**WILSONVILLE CITY HALL
DEVELOPMENT REVIEW BOARD PANEL A**

MONDAY, FEBRUARY 8, 2016 - 6:30 P.M.

A. Resolution No. 323.

Exhibit A1
Staff Report
Wilsonville Planning Division
Advance Road Middle School

LU3.04

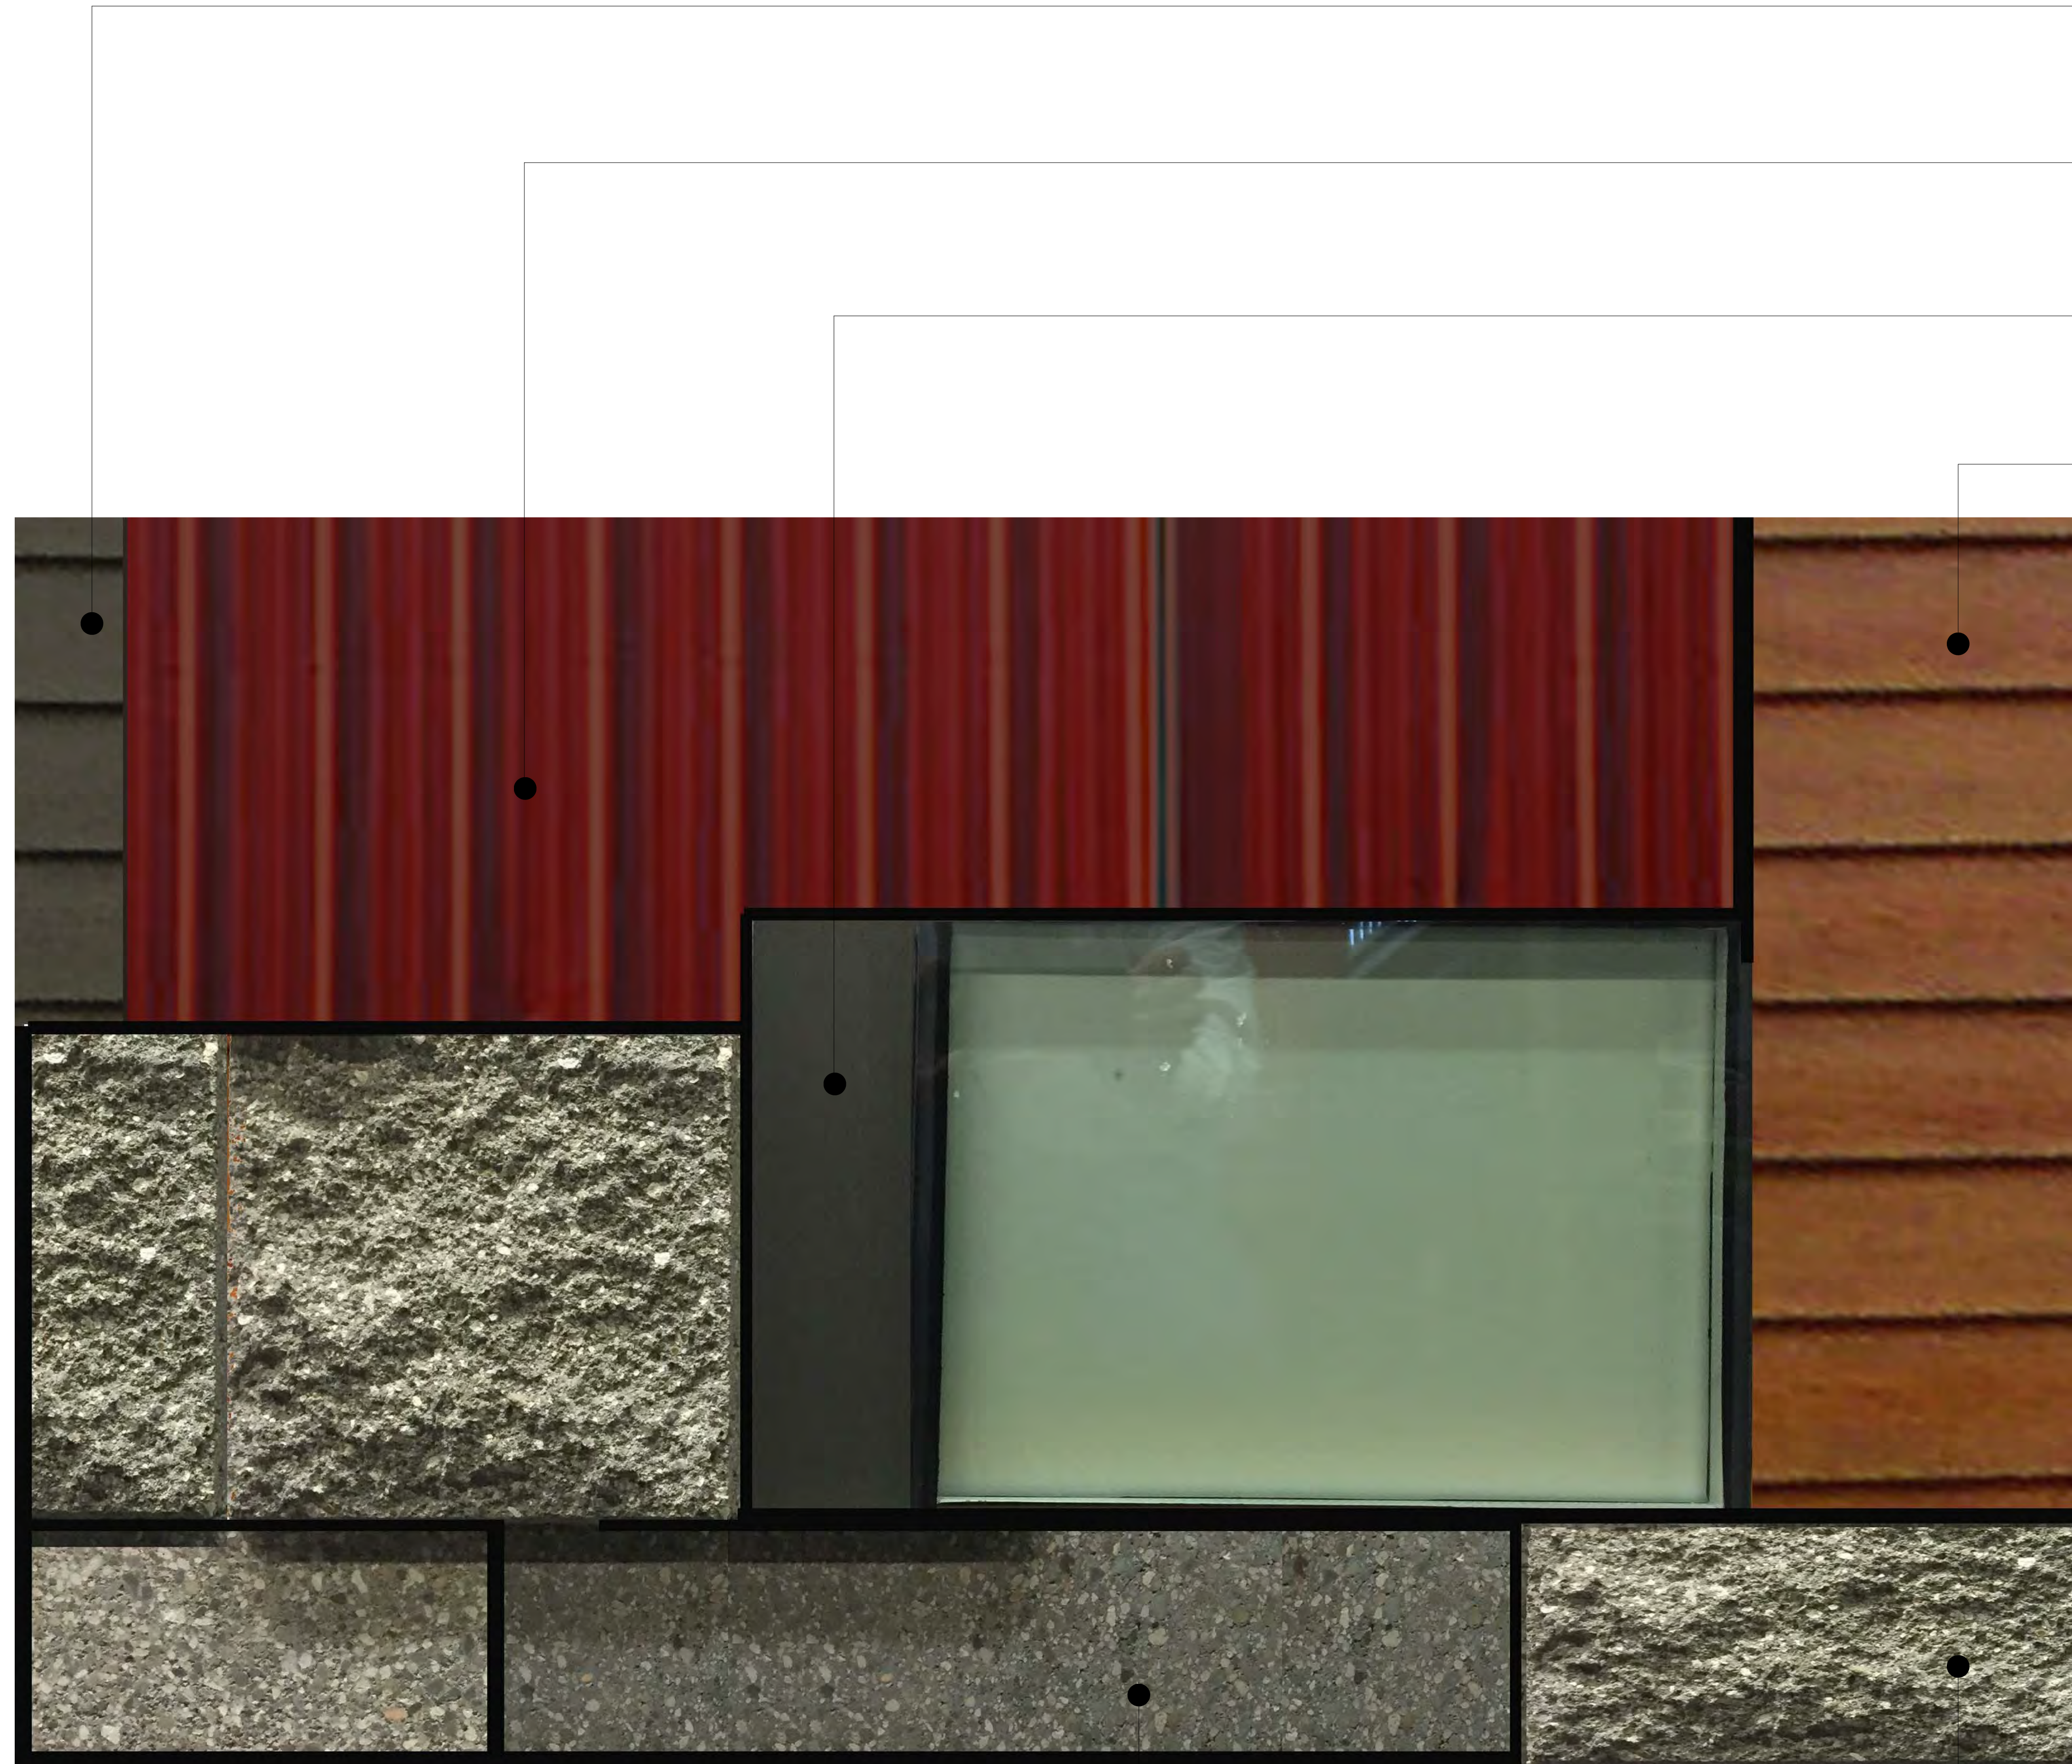
- One monument sign located near the northern entrance to the northwest parking lot. The sign is proposed to be approximately 12 feet wide and 4 feet high featuring the school name, address, and reader board. The sign location is shown on Sheet LU2.01 and the design is illustrated on Sheet LU3.04.
